PROC-FB/CB/PROD-4884/2020

Wellhead Control Panels

TECHNICAL CLARIFICATION # 03

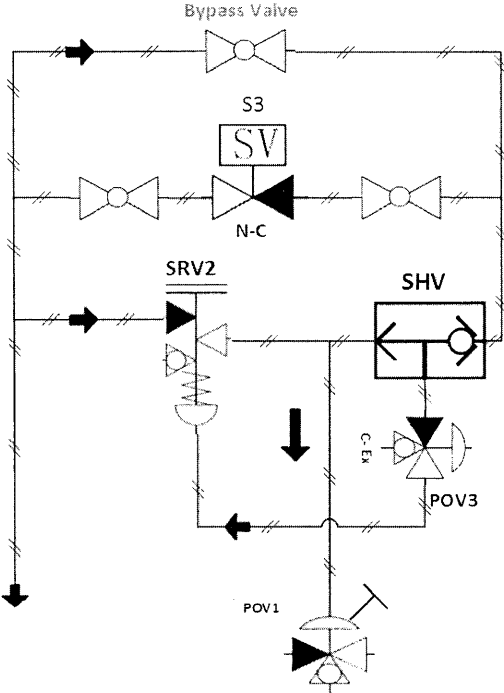
S #	Query	OGDCL Reply
1	<p><i>Since downstream air pressure of S3 solenoid valve will be released through SRV2, therefore shuttle valve will be required in between S3, POV3 &amp; SRV2/POV1 to meet the functional requirement of opening of SSV remotely through S3.</i></p>  <p>The diagram is a pneumatic schematic. At the top, a line with an arrow pointing right goes through a 'Bypass Valve'. Below this, a line goes through a solenoid valve labeled 'S3'. In parallel to the S3 valve is a shuttle valve labeled 'SV'. Below the S3 valve is a normally closed valve labeled 'N-C'. Further down, a line goes through a solenoid valve labeled 'SRV2'. In parallel to the SRV2 valve is a shuttle valve labeled 'SHV'. Below the SRV2 valve is a check valve labeled 'C.E.V.'. Below the C.E.V. are two pressure-overriding valves, 'POV3' and 'POV1'. Arrows indicate flow direction: from the bypass valve, down through S3 and N-C, then down through SRV2 and SHV, then down through C.E.V., and finally down through POV3 and POV1. There are also arrows pointing right from the bypass valve and down from the C.E.V. area.</p>	<p>Since all functional performance warranties &amp; guarantees rests with the vendor, therefore it is essential to meet the material functionality as per tender specs.</p> <p>So for better material functionality, inclusion of shuttle valve is acceptable.</p>

2	<p><i>Quantity of needle valve in pneumatic section was mentioned as 07 in BOM vide clause 11.1.23 while its quantity was 08 in the diagram.</i></p>	<p>Quantity of needle valve mentioned in the BOM vide clause 11.1.23 “Needle valve on pneumatic loops (N1), NACE, 500 psi” has been amended &amp; read as <b>Qty: 08</b></p>
